Report to Planning and Environment Committee

Subject: 200 Albert London Incorporated
200 Albert Street
File Number: Z-9561, Ward 13

Date: November 13, 2023

Figure 3 - Concept Site Plan (November 2022)

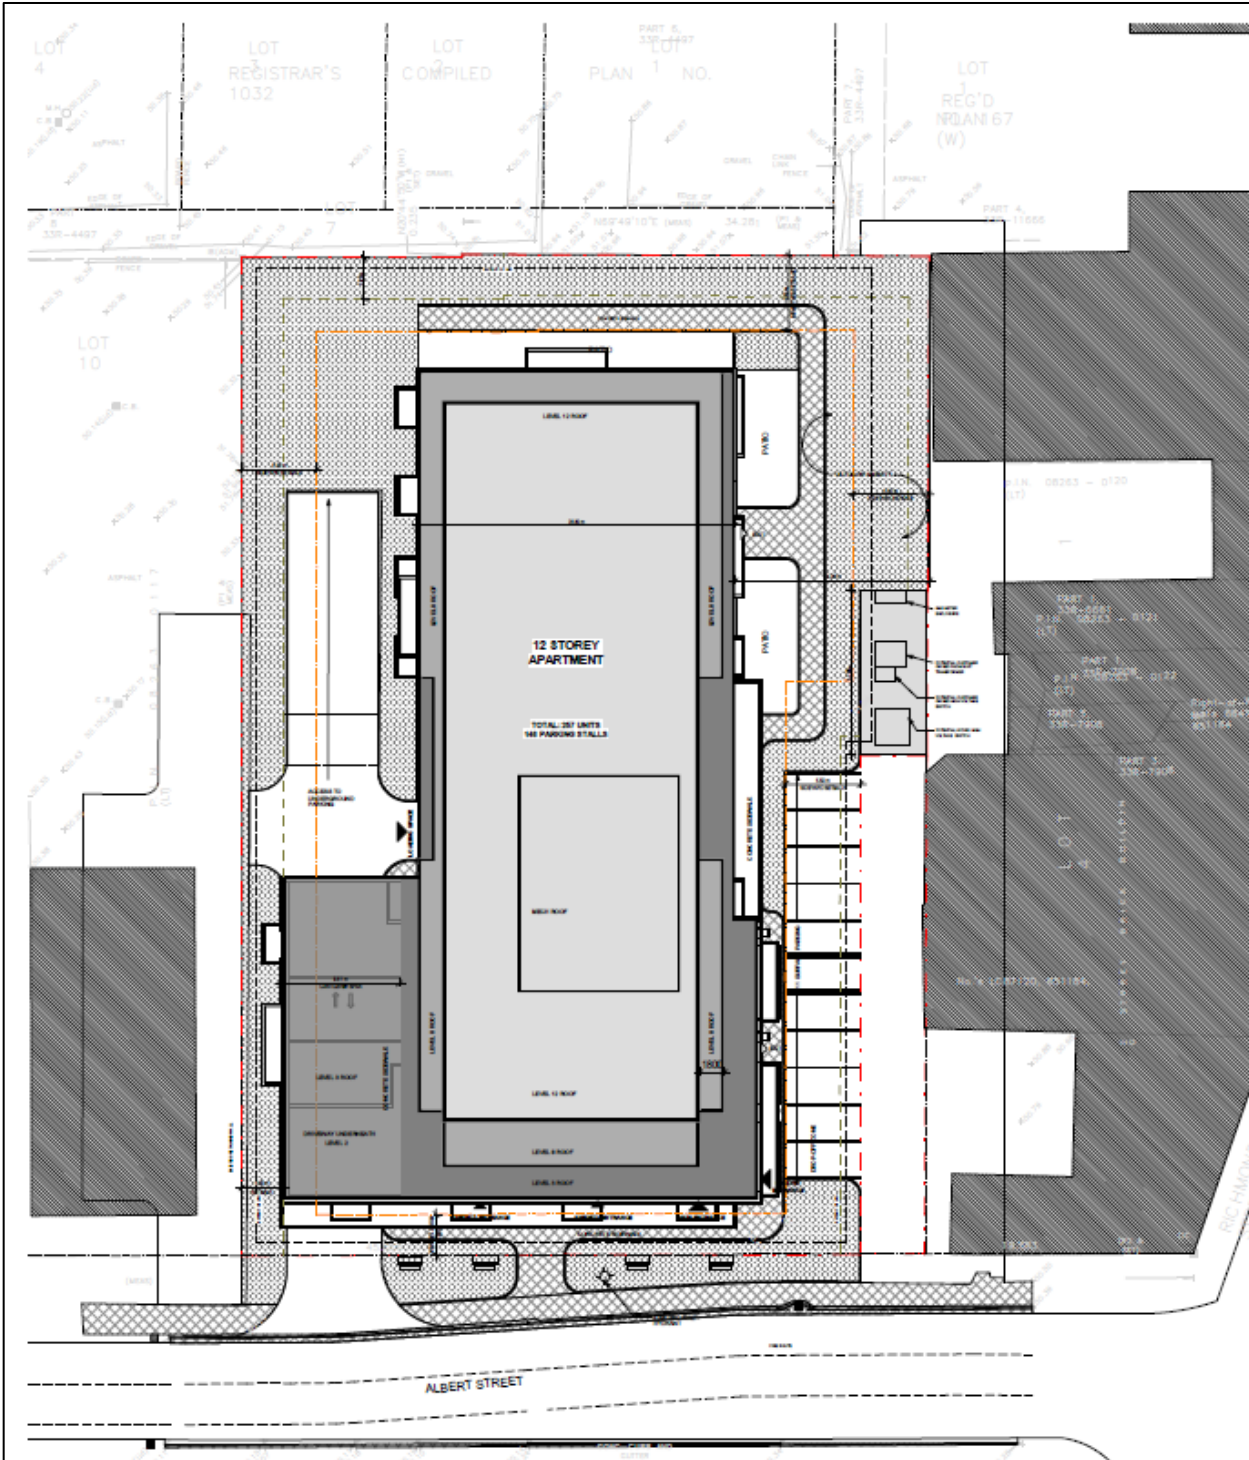
- There are concerns with the proposed loading space. Larger moving vehicles have the potential to block off access to the underground parking garage.
- Need a lay-by for the para-transit vehicles (as per the Site Plan Control By-law 6.8.1).

- Ensure that there is an adequate separation distance, setbacks and buffers between the proposed development and adjacent land uses. Increase the rear-yard setback to between 10m-12.5m, instead of the proposed 5.5m (as indicated in the site plan). Refer to the London Plan, Policies 253 & 298.

- Primary residential unit windows and patios are located along the side-yard. Increase the 3m west side yard separation distance to 5.5m between the abutting property and podium extension. Refer to the London Plan, Policy 252.

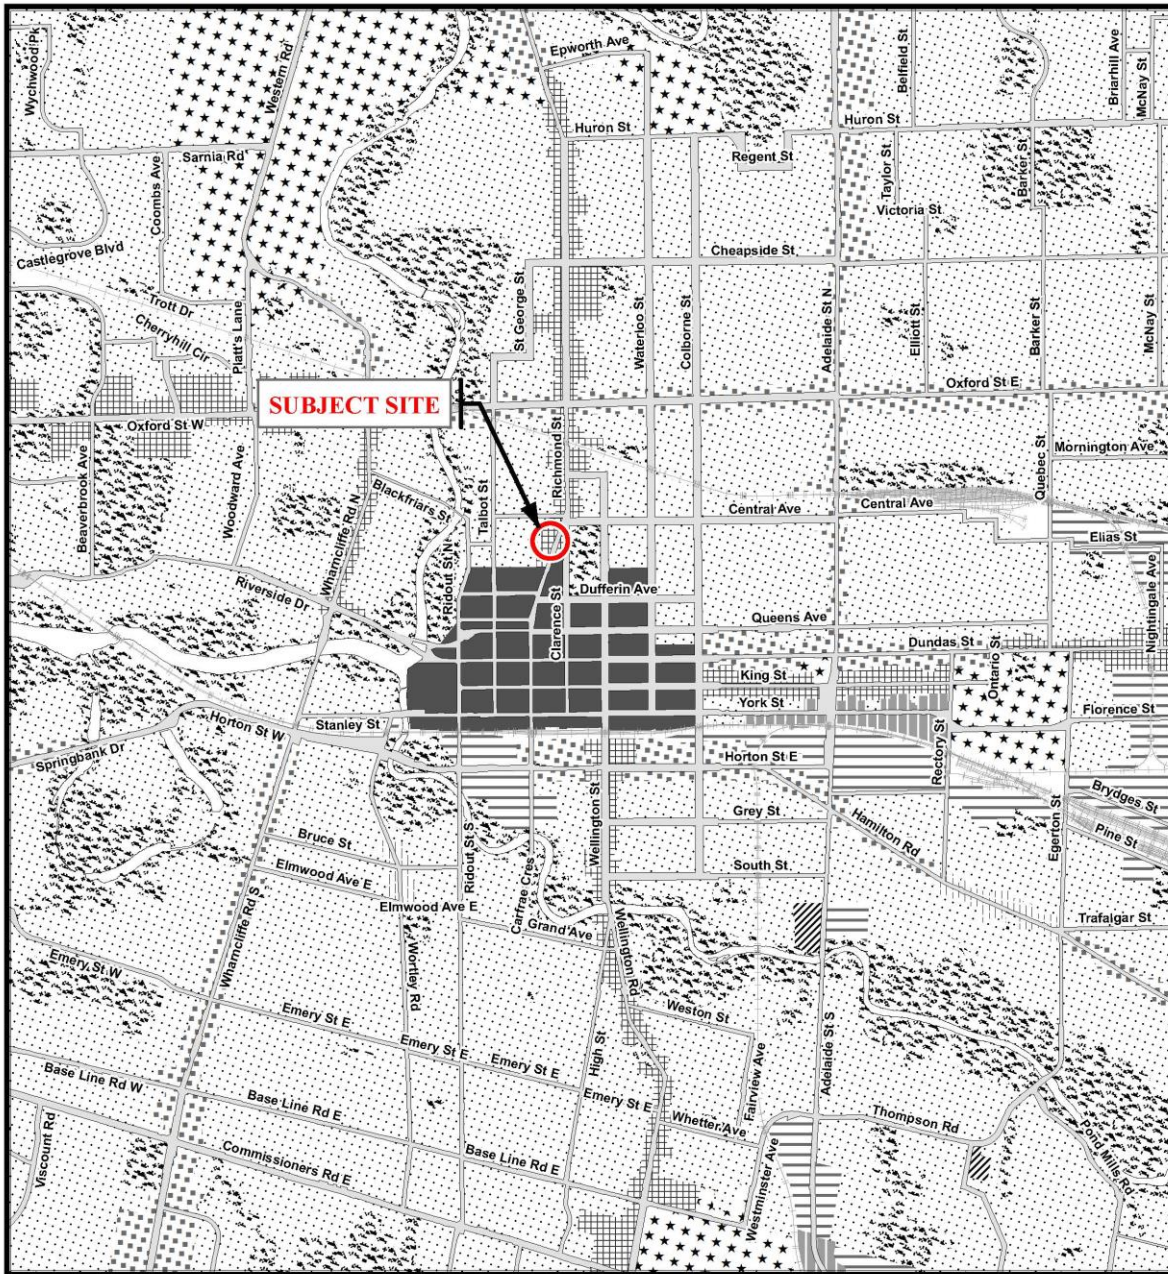
In terms of neighbourhood context, please compare the images below: the top image is the rendering used in the developer's application for an amendment to permit a 12-storey building and the one below it pertains to the latest application for an amendment to permit a 16-storey building. The 16-storey building is a behemoth: there is nothing of it's scale in the area.

I do not know what a density of 926 units/hectare represents in terms of number of residents but it seems to imply an over-intensification when the current zoning requires 250 units/hectare. This influx will have a significant impact on a site where the current residential density is 0 units/hectare.
